10 February 2023

**SSD-31822612: Alterations and Additions to Barker College: written Submission on behalf of the Diocese of Broken Bay**

Figure 4: Draft Floodplain Risk Management Plan

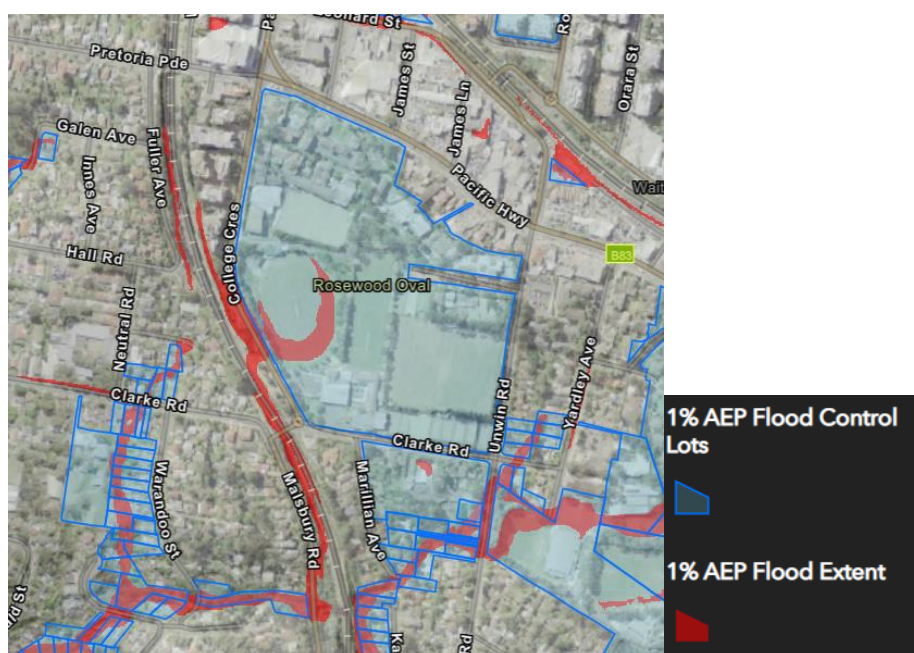
As shown in Figure 4 below, parts of the subject site are identified as land with potential to be inundated by overland flow to a depth greater than 150mm during a 1% Average Exceedance Probability (AEP) flood event. Therefore, the site has the potential for upstream flood impacts.

The SSD Application has not included a flood or hydrological assessment and the Urbis Environmental Impact Statement has not appropriately addressed this Study and Plan.
